Date : Le 23 février 2021	Addenda/Addendum : A-M-01
À/To : Agence spatiale canadienne Centre spatial John H. Chapman 6767, route de l'Aéroport St-Hubert (Québec) J3Y 8Y9	Projet/Project : Agence spatiale canadienne Réaménagement vestiaire des femmes
	N° de projet : 27200022
Att. : Mme Josée Brassard	Propriétaire : Agence spatiale canadienne
Distribution : Par ASC/By CSA

FIN DE L'ADDENDA A-M-01

projet:
PAVILLON 4
RÉFECTION DOUCHES
VESTIAIRES DES FEMMES
 6767 route de l'aéroport, Saint-Hubert, Qc

scale: N.T.S.	date: SEPTEMBER 2020
drawn by: YANNICK JOYAL	#project: #27200022
prepared by: ALEXANDRA GIRARD, Eng.	#sheet: M511

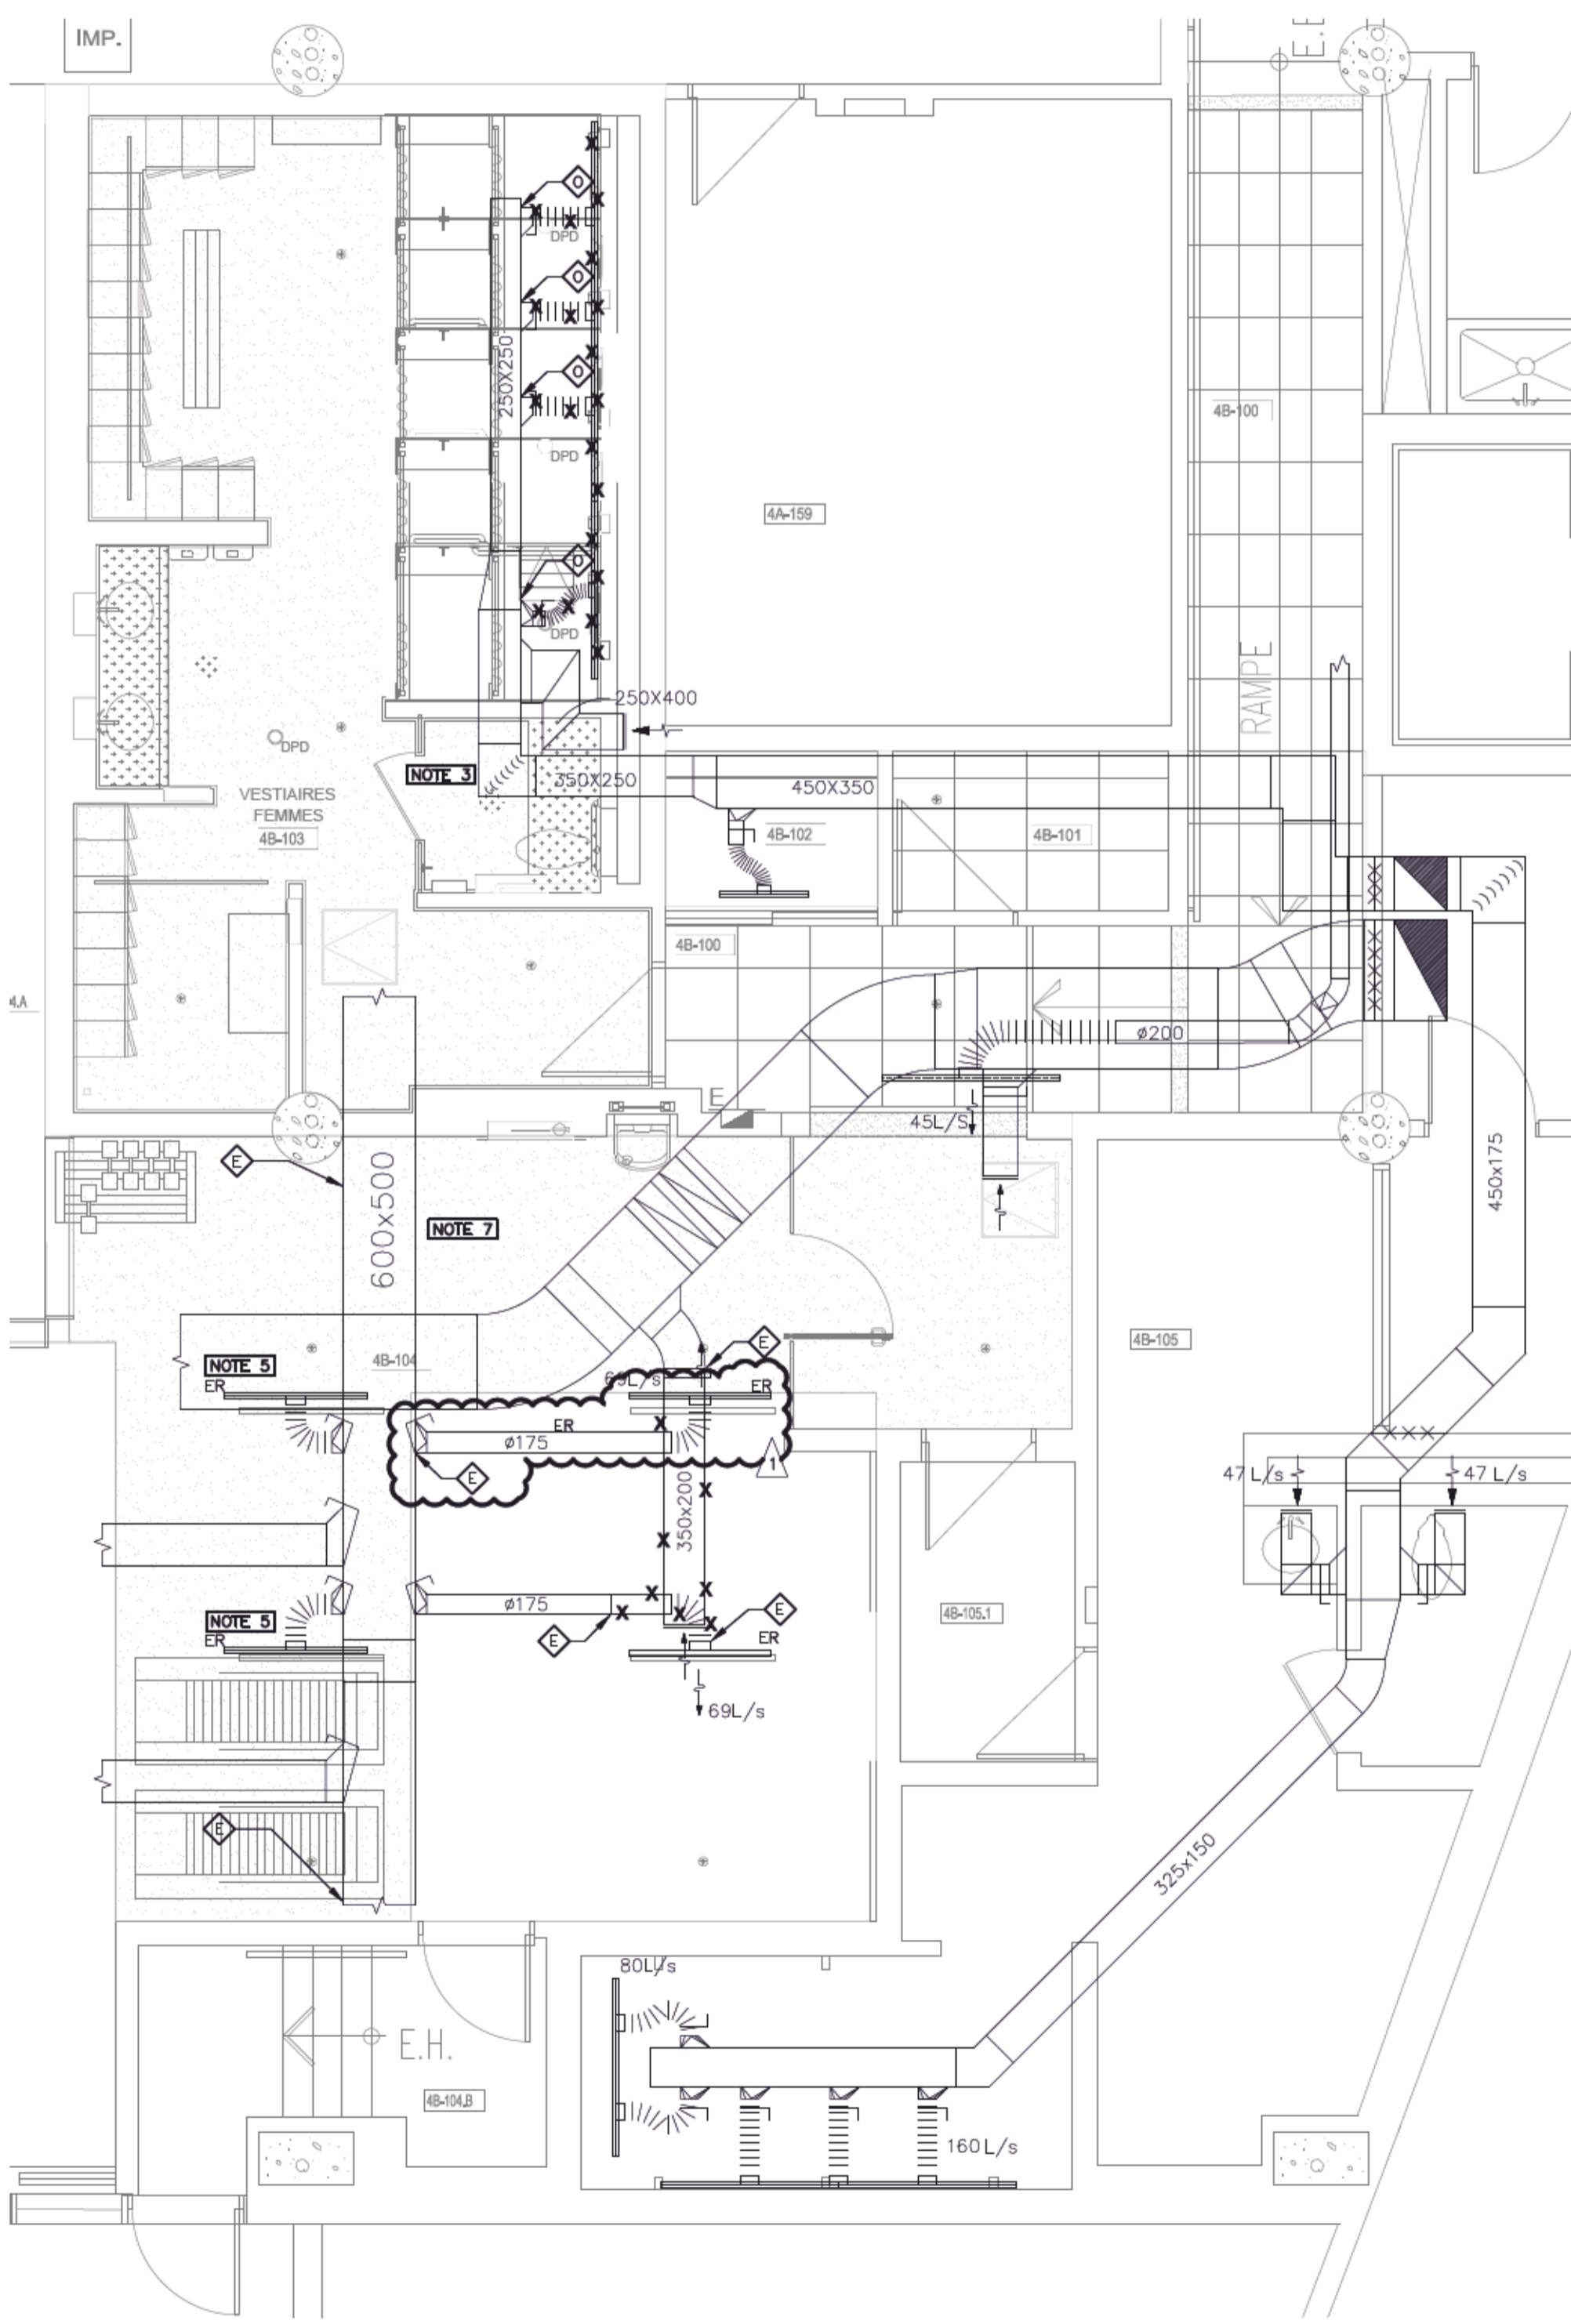
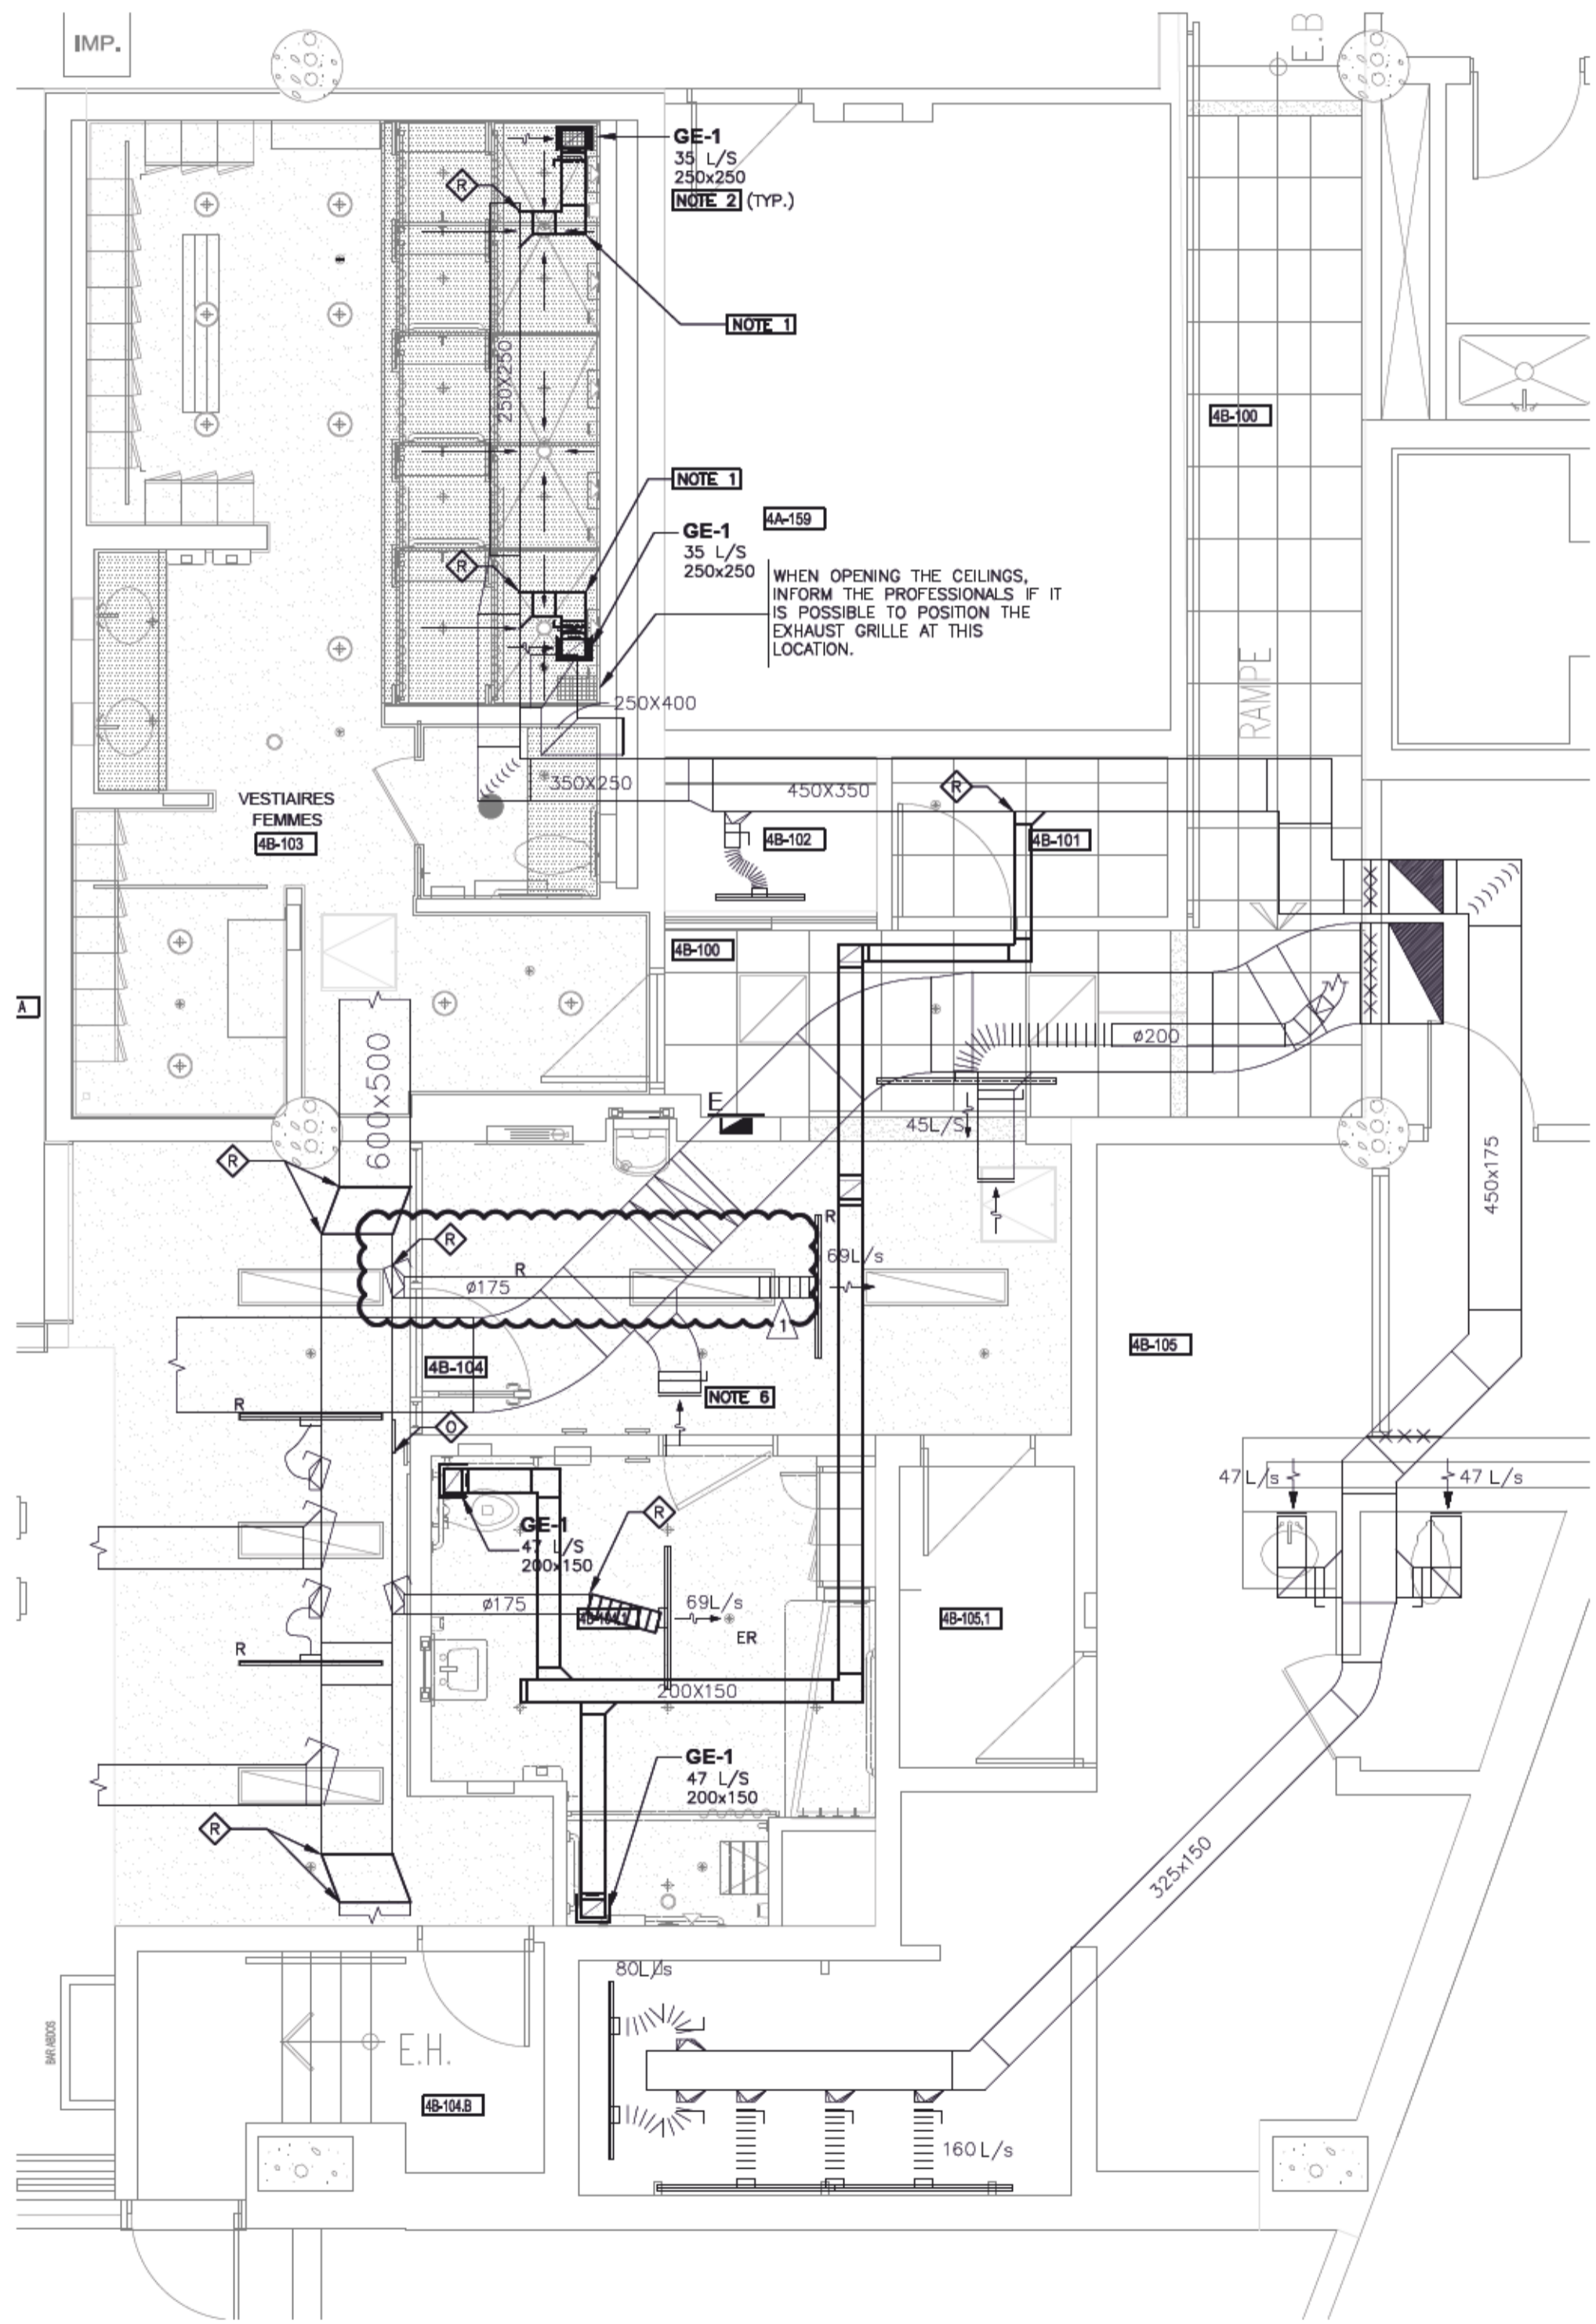
<u>Lexique pour motifs</u>	Motifs
Demande du client : DC Coordination de chantier : CC Coordination des professionnels : CP Conséquence des travaux de base : CB	
<p><i>Le présent addenda fait partie intégrante des plans et devis de mécanique émis pour soumission en date du 19 novembre 2020.</i> <i>This addendum is an integral part of the drawings and specifications issued for tender november 19th, 2020.</i></p> <p>1. <u>MÉCANIQUE/MECHANICAL</u></p> <p>1.1. Plan M211 - Plomberie / Plumbing</p> <p>a) Modification de la portée des travaux de remplacement de la tuyauterie d'alimentation en eau domestique. / Modification of the scope of work for the replacement of domestic water supply piping.</p> <p>1.2. Plan M511 - Ventilation / Ventilation</p> <p>a) Correction du plan concernant le déplacement du conduit de 175mm de diamètre. / Correction of the plan regarding the relocation of the 175mm diameter duct.</p>	<p>DC</p> <p>CP</p>

7. RELOCATE THE EXISTING VENTILATION DUCT FOLLOWING THE ADDITION OF WALLS UP TO THE SLAB.
